Section 4.0 - Specification for Community Monitoring Amendment Submission Data: May 07, 2008

Title Section 4.0 - Specification for Community Monitoring

Amendment #1

Elevation Air Monitoring Locations

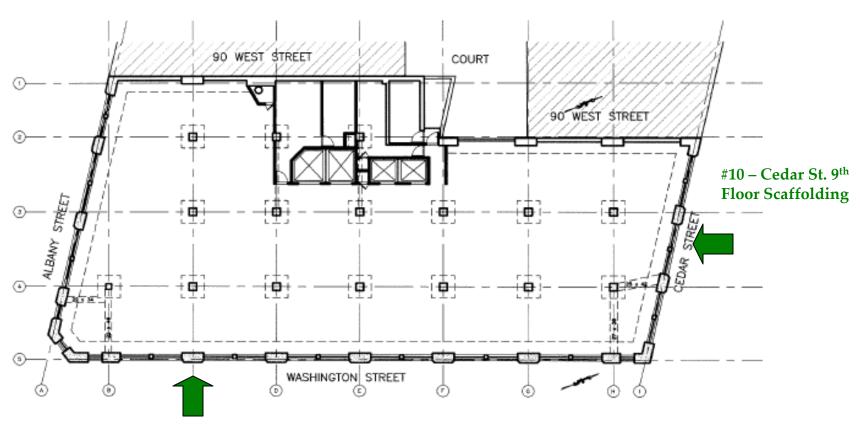
Sub-section 3.0 – "Elevation Air Monitoring Stations" diagram;

Add attached diagram for stations #9 & #10 on the 9th floor.

See attached diagram of the proposed #9 & #10 monitoring locations on the 9^{th} floor.

Add #9 – Former station #7 moved on (Implementation Date) to Southern end of the east side of the 9th floor scaffold

Add #10 – Former station #8 moved on (Implementation Date) North side of the 9th floor scaffold
